STAFF REPORT
COMMUNITY DEVELOPMENT DEPARTMENT

SUBJECT: Apex Northwest No. 6
FP-2025-0003

I. PROJECT DESCRIPTION

Final Plat consisting of 61 single family building lots and eleven (11) common lots on 29.11 acres of land in the R-2 and R-8 zoning districts for the Apex Northwest Subdivision No. 6.

C. Final Plat (dated: 01/21/25)

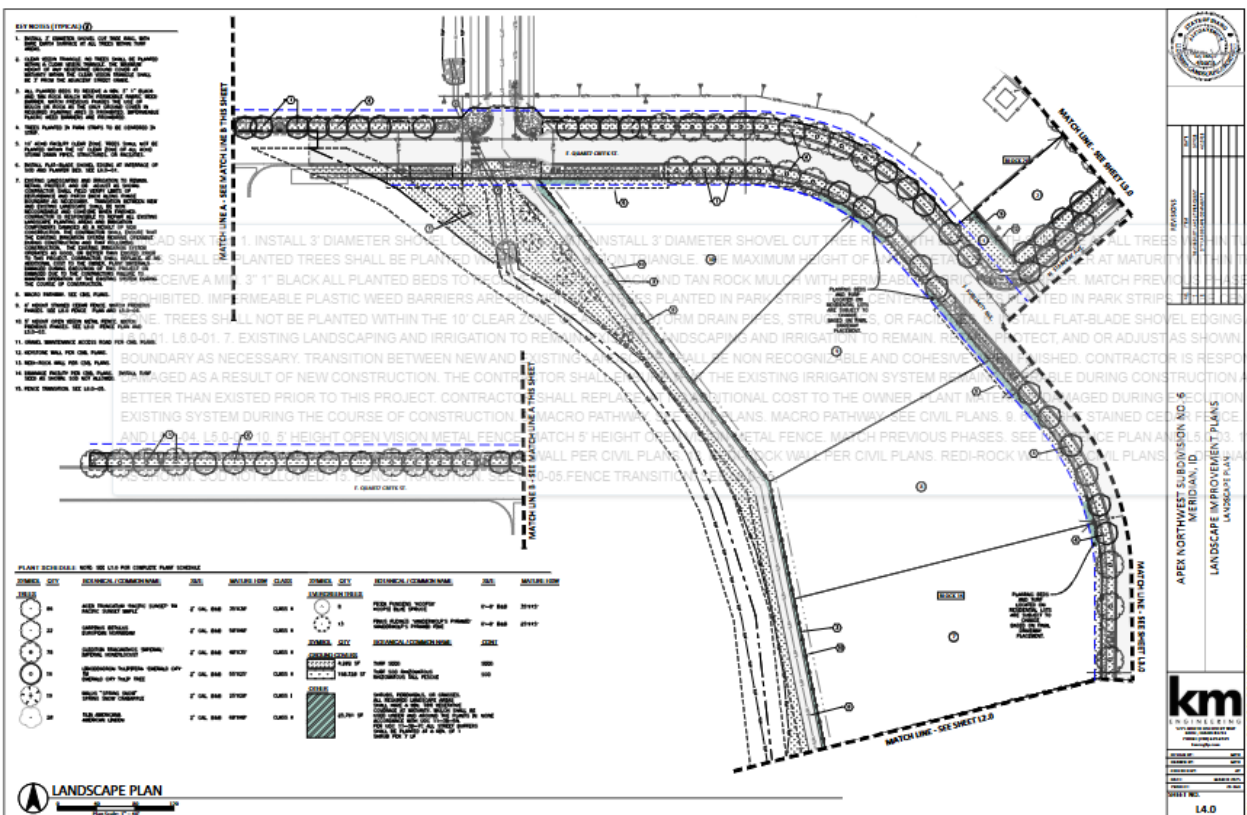
3. Prior to submittal for the City Engineer's signature, have the Certificate of Owners and the accompanying acknowledgement signed and notarized.
4. The final plat prepared by KM Engineering, dated: 01/21/2025, included in Section V.B shall be revised as follows:

- a. Note #9: Include the recorded instrument numbers for the ACHD temporary license agreement.
 - b. Note #17 and 18: Include the recorded instrument number of the ACHD permanent easement.

- c. Note #15 and 16: Include the recorded instrument number of the City of Meridian Sanitary Sewer and Water Easement.
- d. Add a plat note stating “direct lot access to S. Sublimity Avenue is prohibited except for Lots 3-10, Block 14.”

A copy of the revised plat shall be submitted with the final plat for City Engineer signature.
